S E R V I C E N O T E

4338A Milliohmeter

Modification to eliminate CPU hang up due to defective X'tal oscillators

Figure 1.

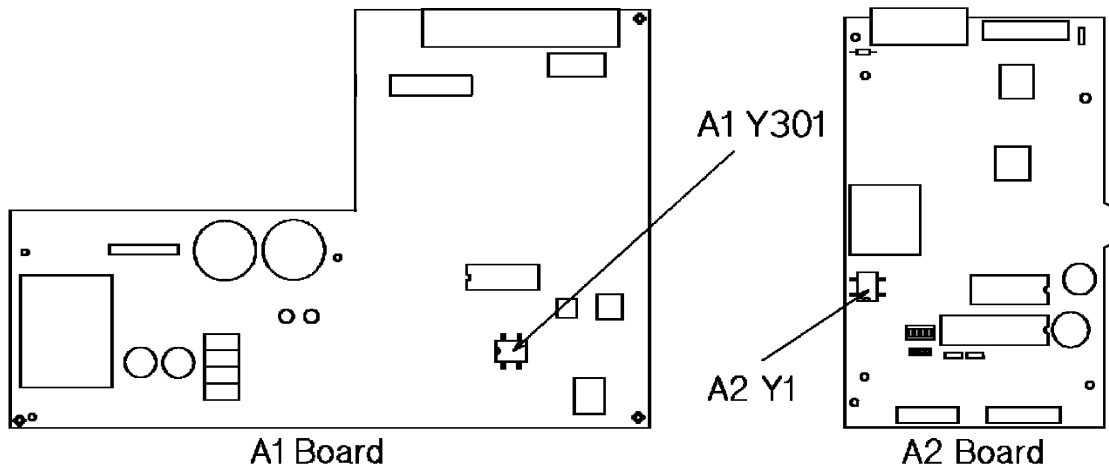
The 4338A units with serials given above may hang up intermittently. This is caused by the X'tal oscillator chip which has a problem in its manufacturing process. Two oscillator chips are used in the 4338A.

If the unit exhibits the symptoms given above, try replacing the two X'tal oscillator chips with new ones. These components are SMD (Surface Mounted Devices) but don't require any special tools or techniques to replace them. Their pin pitch is wider than the general SMD.

Figure 1. shows the X'tal location.

Part No.	Qty.	Ref Designator	Description
1813-0774	1	A1 Y1	X'tal Oscillator, 20.48 MHz
1813-0708	1	A2 Y1	X'tal Oscillator, 16.0 MHz
